**Re: Florida Power & Light Company
Sweetbay Solar Energy Facility Major Final Site Plan Application
Project Number: F109-002
Staff Report Reply Letter**

Itemized Responses to Staff Report

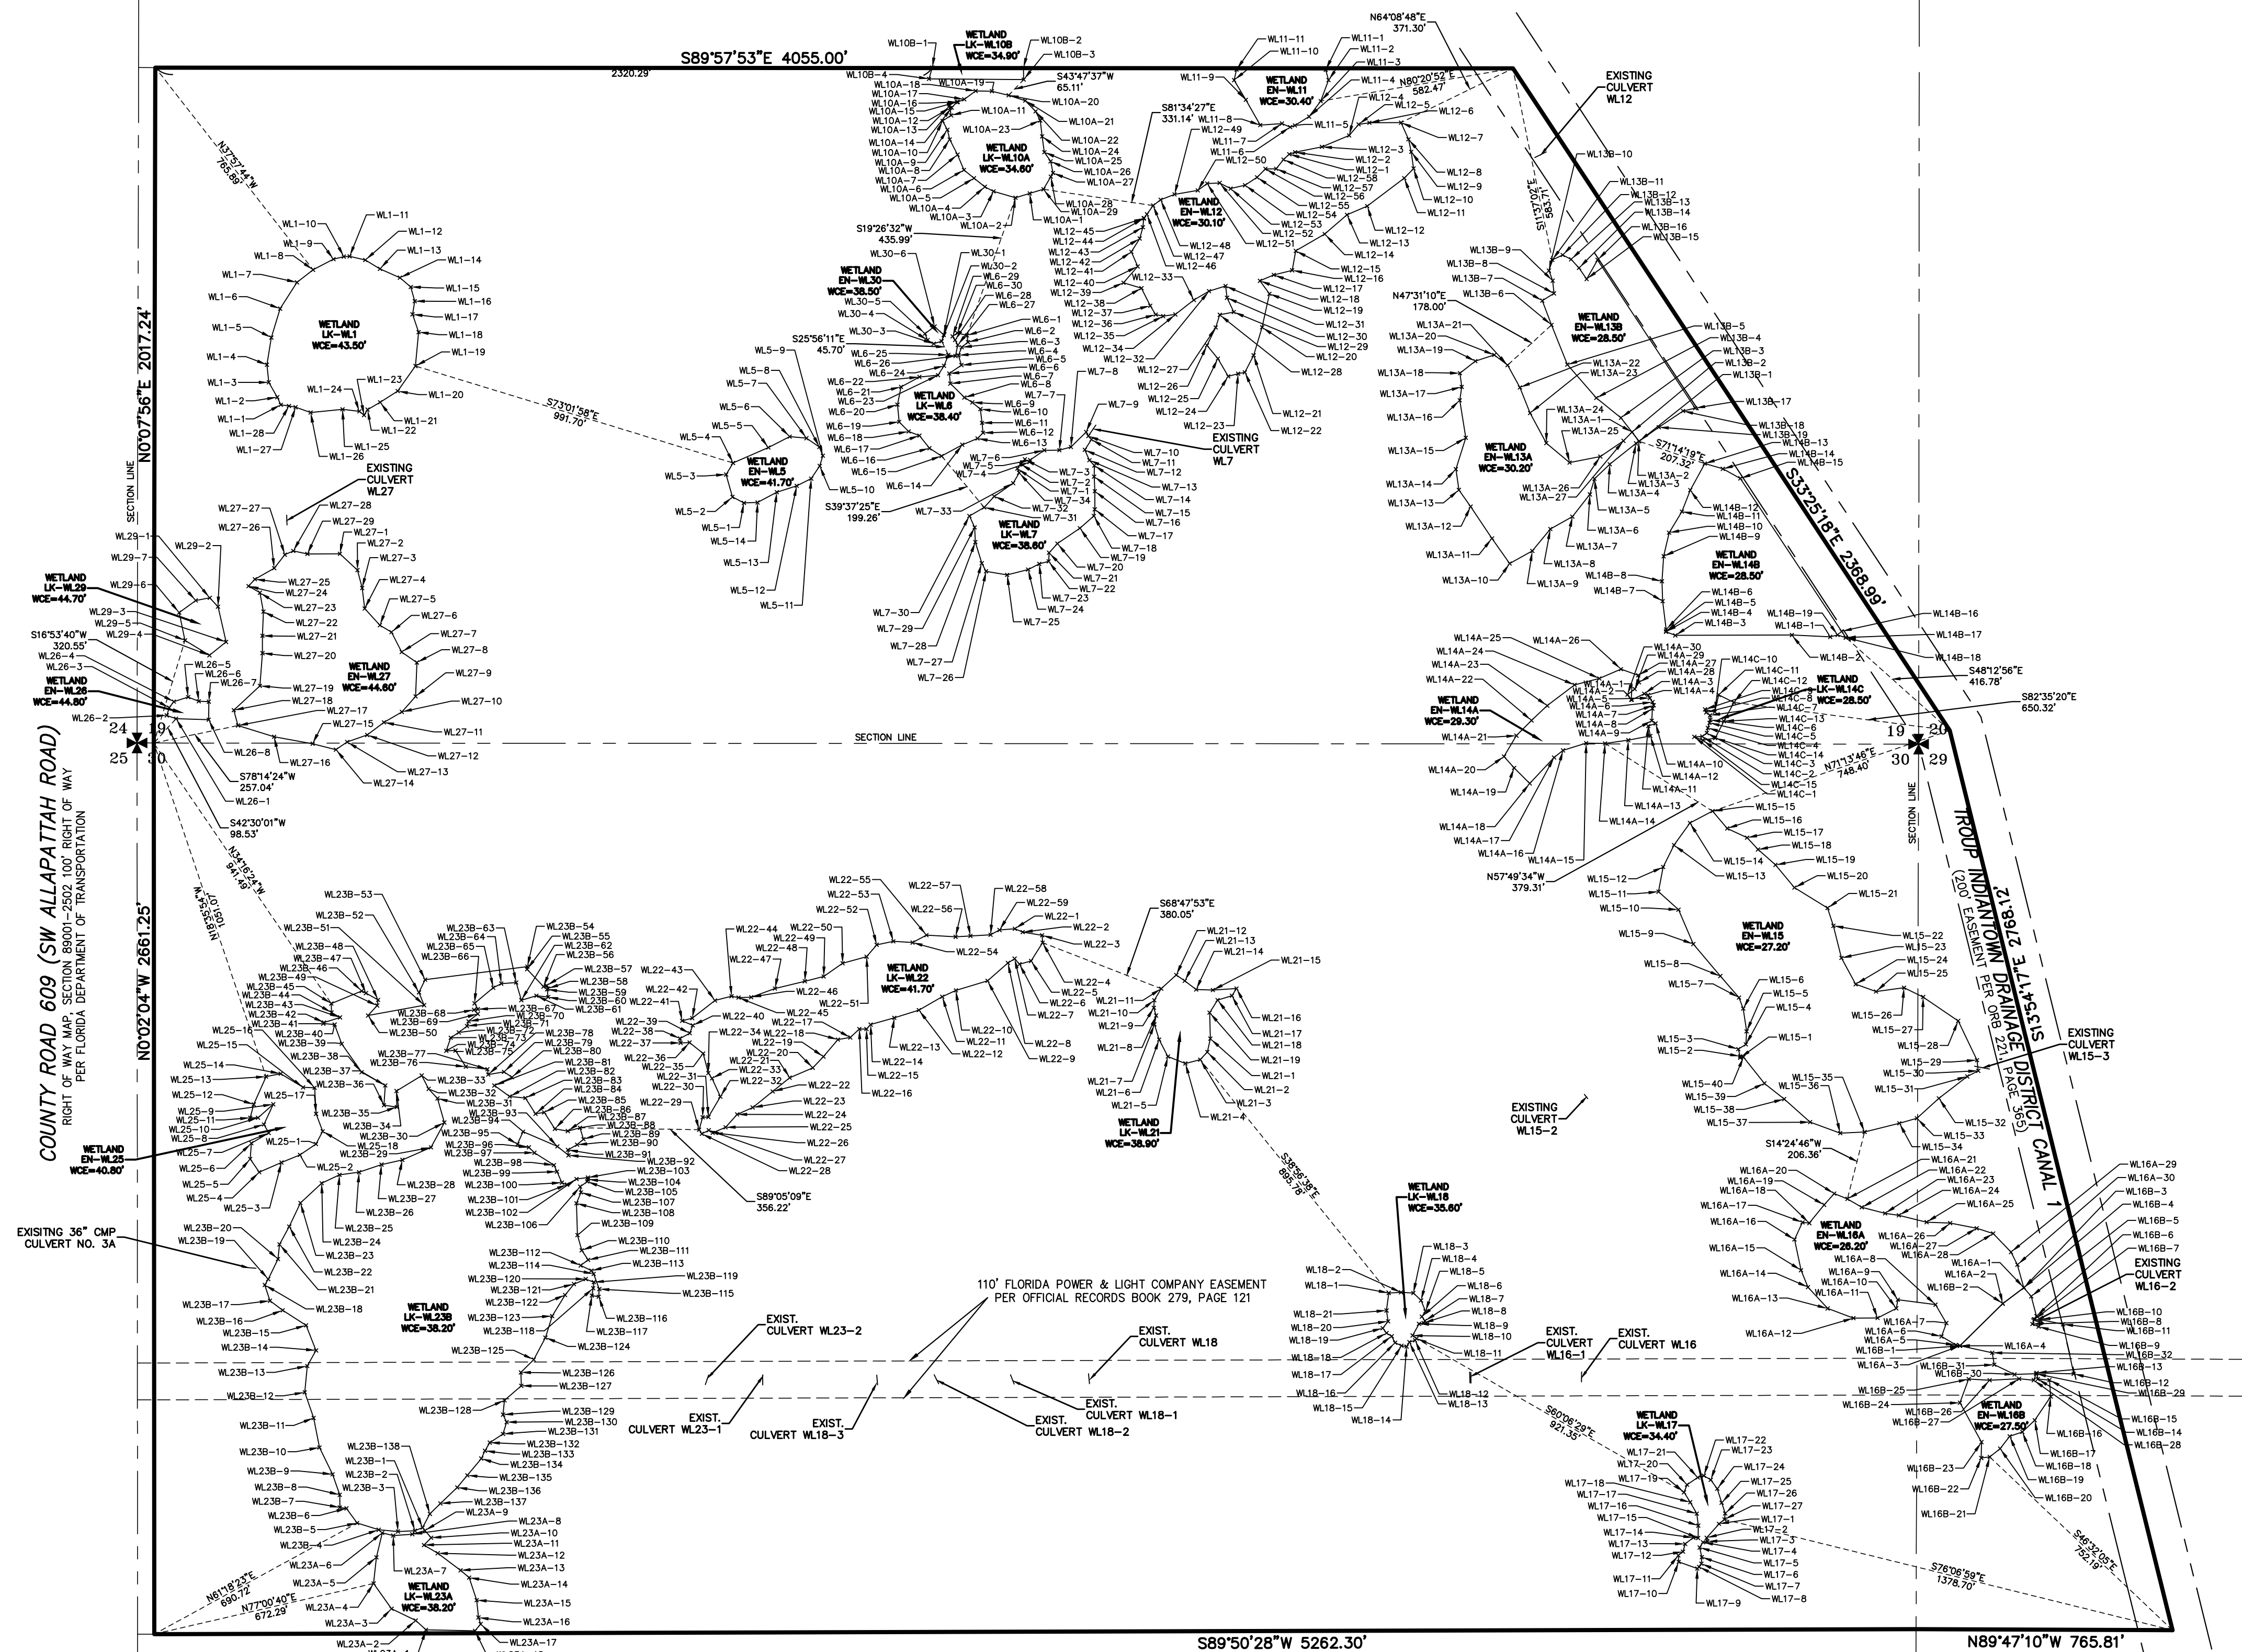
1. **Existing wetland limits should be identified on the survey. [Martin County, Fla., LDR Section 4.384.A.3.a.(1)]**

2. **Existing stormwater management facilities, including pipes and control structures, should be identified on the survey with invert elevations shown. Elevations of existing drainage ditches should be identified on the survey. [Martin County, Fla., LDR Section 4.384.A.3.a.(6)]**

3. **Water levels of existing ponds and wetlands, including seasonal fluctuations, should be shown on the survey. [Martin County, Fla., LDR Section 4.384.A.3.a.(4)]**

The Specific purpose survey identifying the wetland limits, the existing stormwater management facilities and water levels is enclosed.
